PERMIT

SEWAGE DISPOSAL SYSTEM

HOWARD COUNTY HEALTH DEPARTMENT
BUREAU OF ENVIRONMENTAL HEALTH

UBDIVISION Hong Property LOT NUMBER 1 ADDRESS 15801 Old Frederick Road

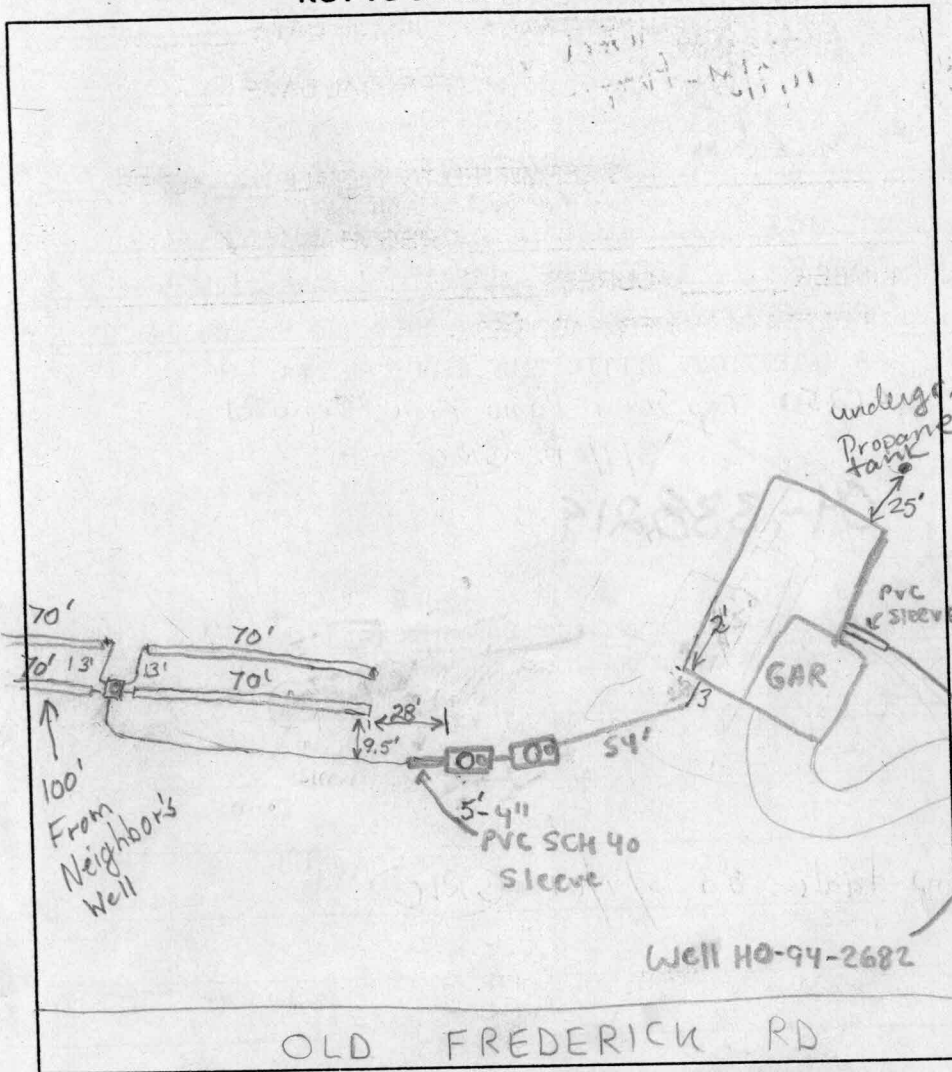
LOCATION: Starting at the left front lot corner as seen from Old Frederick Road, place the distribution box 160 feet down the left lot line and 125 feet off this same lot line. Run (4) 70' trenches on contour in either direction. 12/20/00 OK (BB)

Revised to add pump tank on 5/9/01 - (SRK)

PRE-CONSTRUCTION INSPECTION: 5/9/01 - PUMP SYSTEM REQUIRED, CONTOUR & ELEVATIONS ARE ALL OFF, GRAVITY TO D-BOX & 3' INLET IMPOSSIBLE, BUILDER NOTIFIED - (SRK)

INSPECTION COMMENTS: 5/10/01 - CONTOUR DROPS OFF NEAR (A), OK TO HAVE SLIGHTLY LESS COVER (18\") ON TRENCHES NEAR (A), RUN TRENCHES AS SHOWN ON

APPROVED BP PLAN - (SRK) 5/11/01 O.K. to cover. Need pump and alarm test and house connection for final approval. (BB)
